March 14, 2023

Product Update: 2023 Pilot 2WD Replacement for Incorrect Accessory Trailer Hitch Label

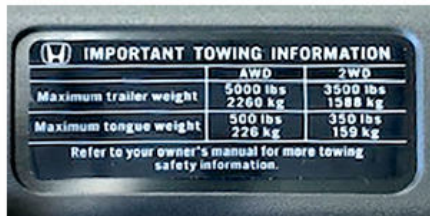
1. Inspect the trailer hitch towing capacity label.

INCORRECT ❌

CORRECT ✅

Does the label have the towing capacity for both AWD (5000 lbs) and 2WD (3500 lbs)?

YES - This bulletin does not apply.

NO - Go to the REPAIR PROCEDURE.

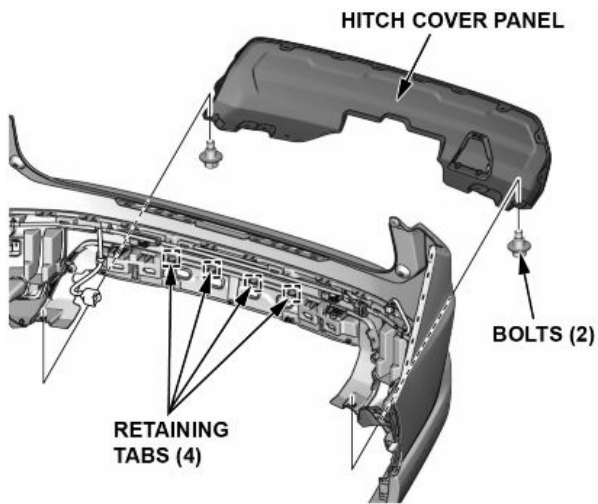
18. Remove the hitch cover panel and discard .

19. Install the replacement hitch cover panel in reverse order.
